City of Ramsey
Agenda
Environmental Policy Board (EPB)
Monday, August 19, 2024
6:30 pm
Council Chambers, 7550 Sunwood Drive NW

Consider Natural Resources Aspects for Parkside Townhomes Preliminary Plat

- Site Location Map
- Preliminary Plat
- Site Plan and Phasing Plan
- Tree Inventory and Preservation Plan
- Landscape Plan with Comments

L1.2

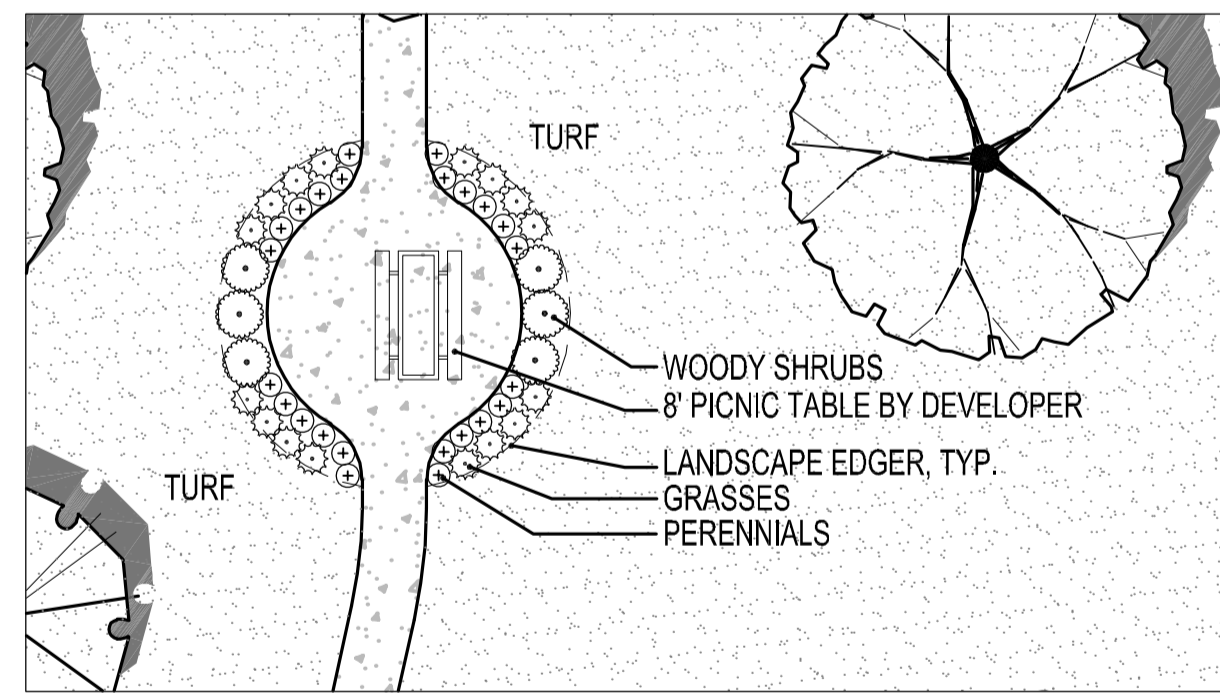
1 - River Birch

River Birch is acceptable in boulevard areas but it MUST be single stem. No clump plantings in the boulevard will be permitted. The clump form is acceptable for any plantings internal to the site. Please add note to Plant Schedule.

PROJECT NO.
22-164
L1.3

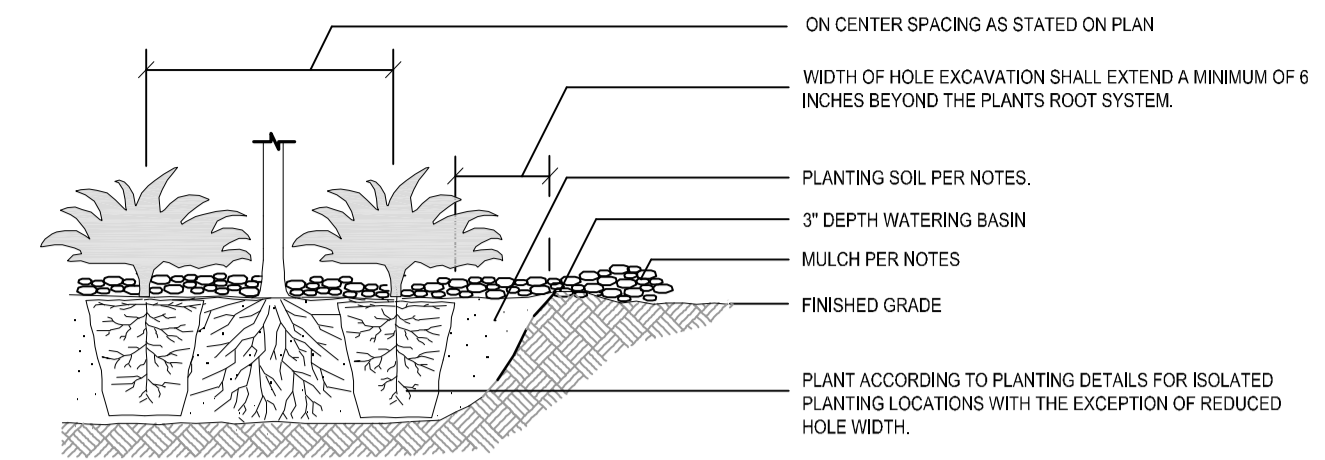
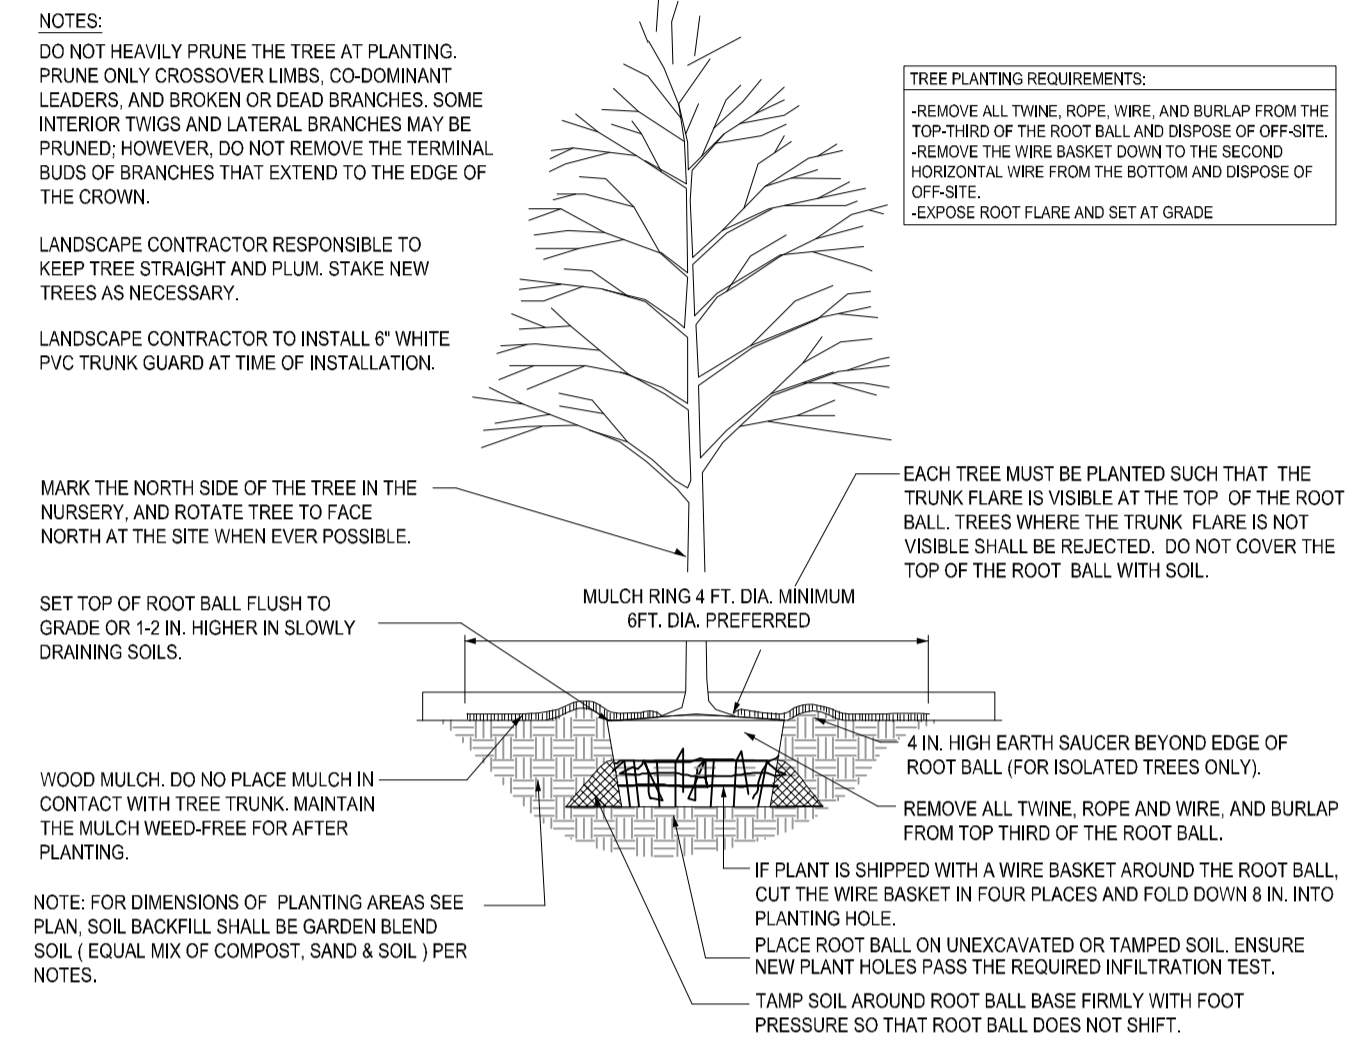
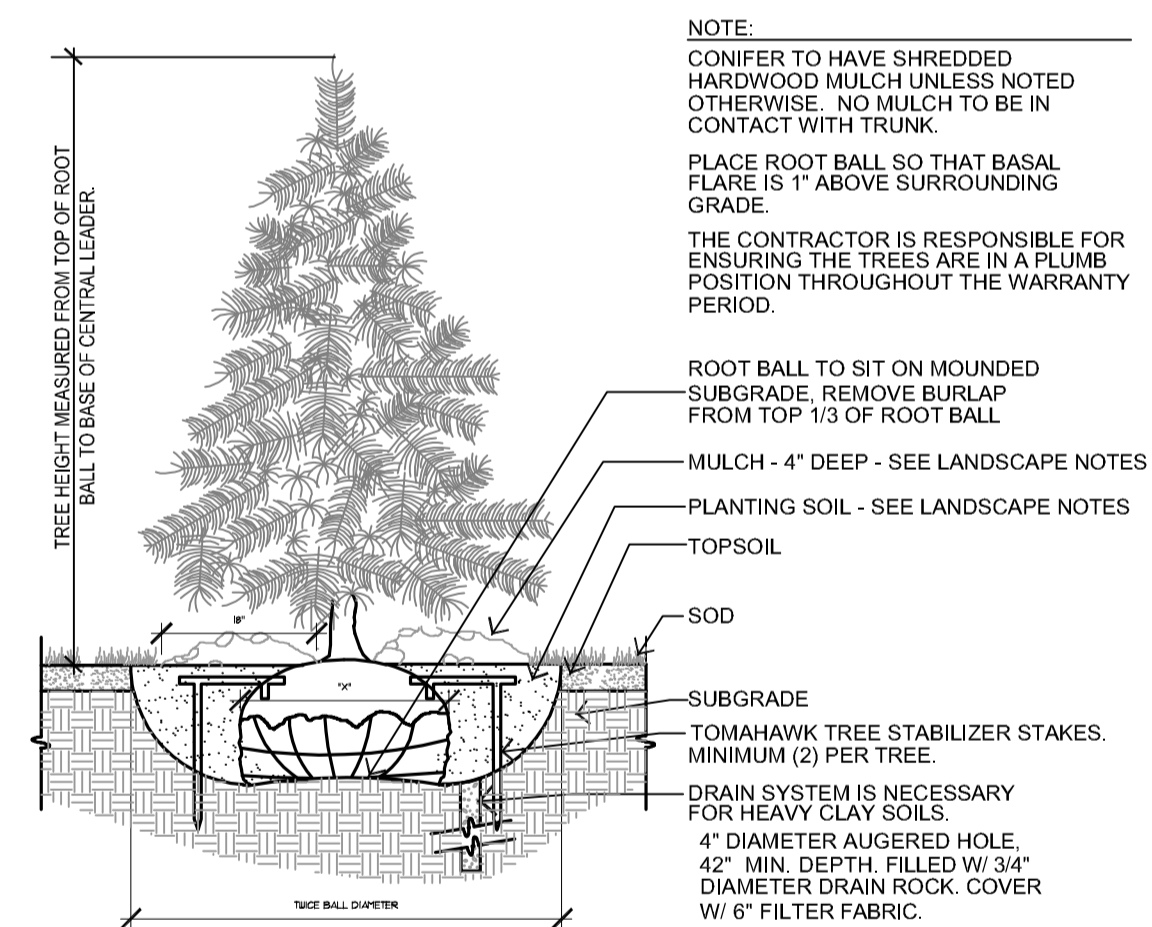
1 - Water Efficient Technology

Irrigation system must include some form of water efficient technology, such as a smart controller and/or soil moisture sensors. Please add a note specifying that system must include some form of water efficient technology in addition to the state required rain sensor.
